# Access Compliance Report

## Public Rights-of-Way

Intersection ID: 6462	Main Street: BURGANDY_DR	Cross Street: MINERAL_SPRINGS_RD	Location: SE
ADA ID: 297A903F0560	Ramp Type: BlendTrans1	Initial Pass/Fail: Fail	Overall Compliance: No
Severity Score: 1.25			
Codes/Mitigation Info/Possible Solution		Field Measurements/Component Compliance

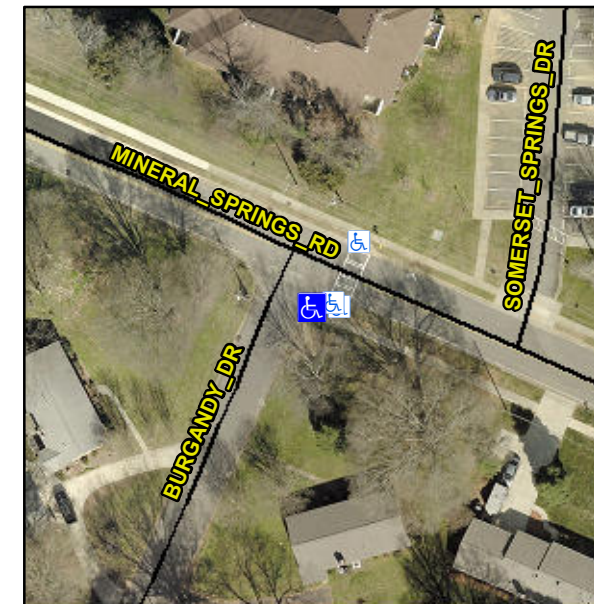
**Remove & Replace Curb Ramp With Two New Directional Ramps or Equivalent.**

**Not Found, R304.5.3**
